**Site Characterization for Banana
Patch Properties,
Pearl City, Oahu, Hawaii**

**Honolulu Rail Transit Project
January 2015**

Prepared for:
Honolulu Authority for Rapid Transportation

Figure 4-4
Sediment Results
above Screening Levels
Site Characterization Report
of Banana Patch Properties
Pearl City, Oahu, Hawaii
Honolulu Rail Transit Project

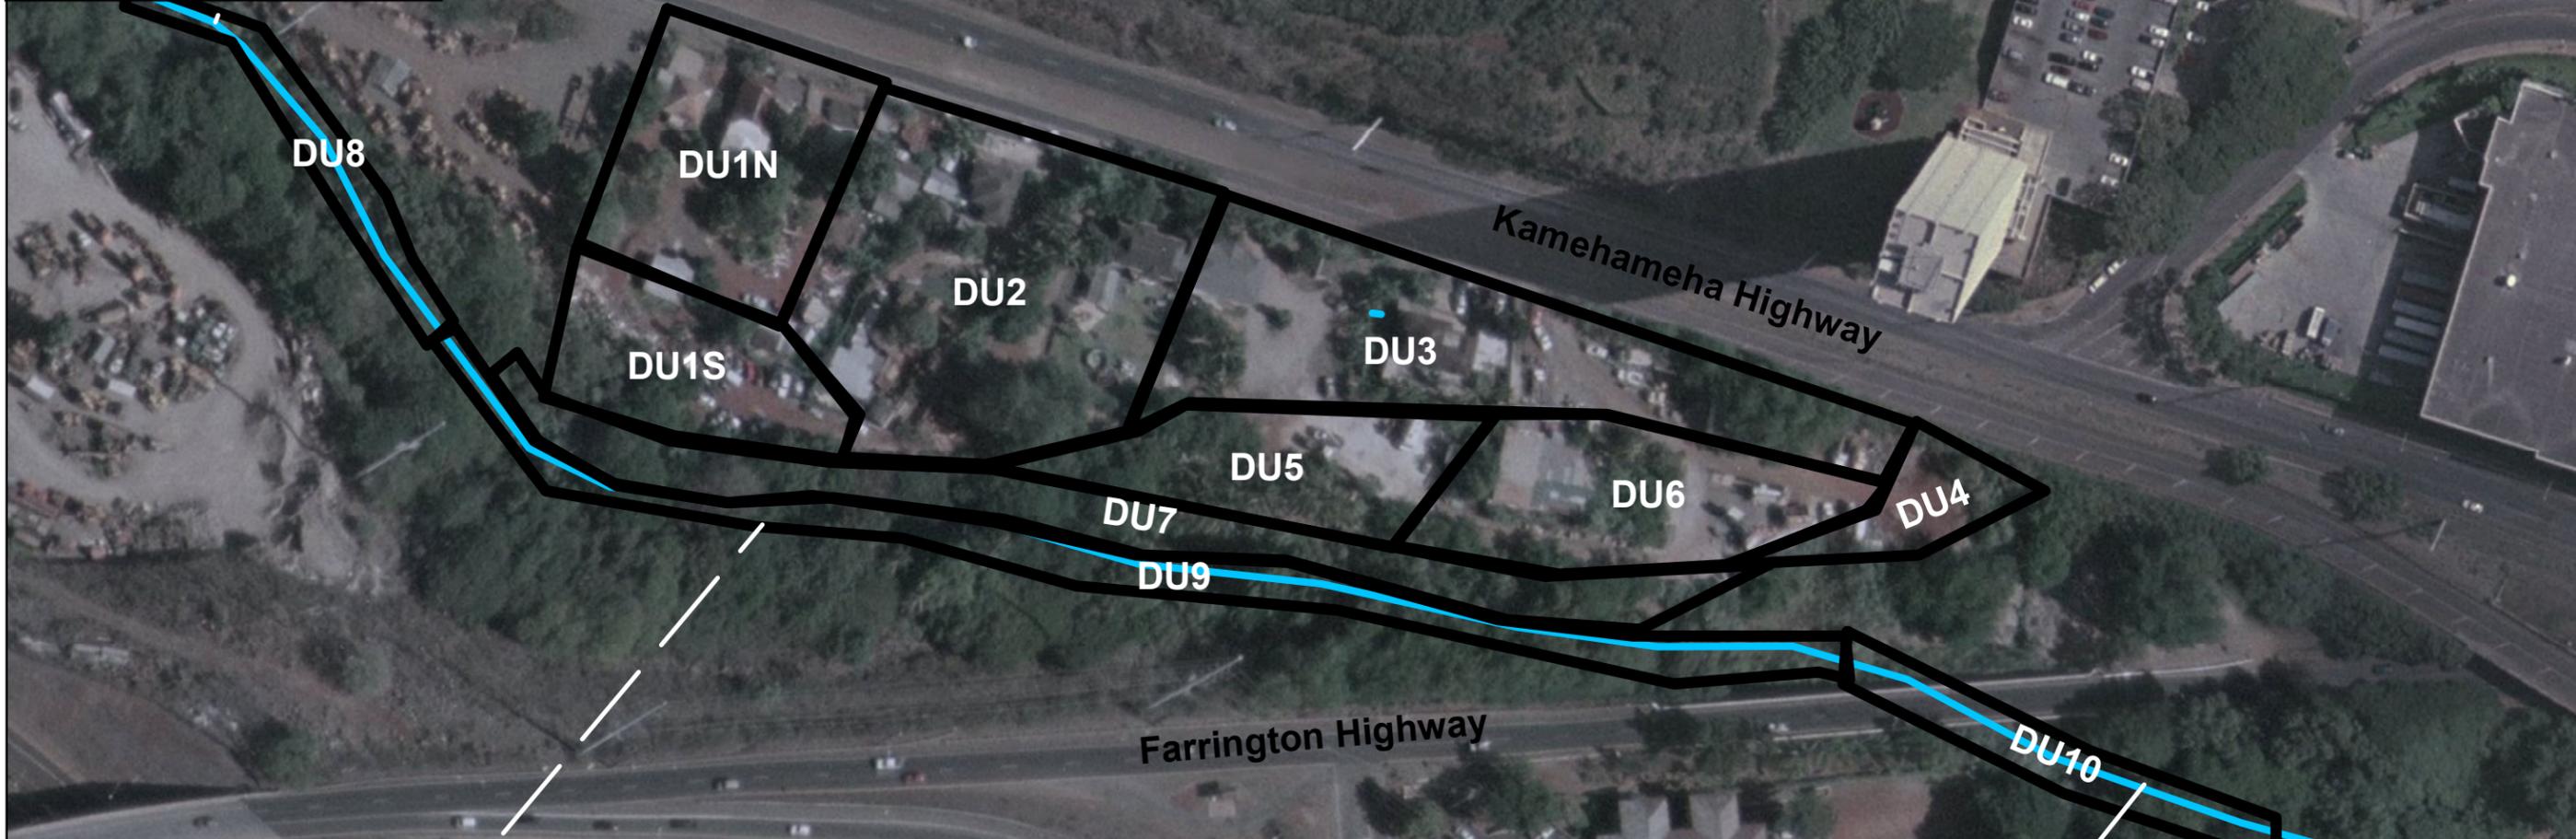
Figure 4-4. Sediment Data	The cadmium data for DU9 and DU10 in Figure 4-4 are incorrect. According to the lab report (and Table 2) the concentration of cadmium was 0.54 mg/kg in the DU-9 sample and 1.0 mg/kg in the DU-10 sample. The reported concentration of lead in the DU-9 sample is correct (45.1 mg/kg), but the reported concentration of lead in the DU-10 sample should be 17.5 mg/kg, not 45.1 mg/kg as indicated in the figure.
	Figure 4-5. Groundwater Data	If groundwater samples were not filtered prior to testing, the heptachlor is probably related to chlordane detected in shallow soils in most of the DUs (low ppm levels but below EALs) . The presence of organochlorine pesticides suggests that there was sediment in the samples. Runoff into the stream should be controlled during future development to minimize the movement of chlordane into aquatic habitats.
	Appendix G, Section 3.8	Briefly describes the RSDs based on triplicate results, but again, very little information about the locations of the triplicates or what the results mean for the DU where the samples were collected.

Section	Location	HDOH Comment	Response to Comment	HDOH Follow-Up Comment	Response to Comment
	Figure 4-4. Sediment Data	The cadmium data for DU9 and DU10 in Figure 4-4 are incorrect. According to the lab report (and Table 2) the concentration of cadmium was 0.54 mg/kg in the DU-9 sample and 1.0 mg/kg in the DU-10 sample. The reported concentration of lead in the DU-9 sample is correct (45.1 mg/kg), but the reported concentration of lead in the DU-10 sample should be 17.5 mg/kg, not 45.1 mg/kg as indicated in the figure.	The figure will be revised to reflect the correct analytical results.	None	NA
	Figure 4-5. Groundwater Data	If groundwater samples were not filtered prior to testing, the heptachlor is probably related to chlordane detected in shallow soils in most of the DUs (low ppm levels but below EALs). The presence of organochlorine pesticides suggests that there was sediment in the samples. Runoff into the stream should be controlled during future development to minimize the movement of chlordane into aquatic habitats.	Groundwater samples were filtered for metals analysis but not for other analyses. BMPs to control runoff are currently in place above the ordinary high water mark and are anticipated to be maintained throughout construction. Future construction plans include geotextile and vegetated berms along the stream bank.	None	NA
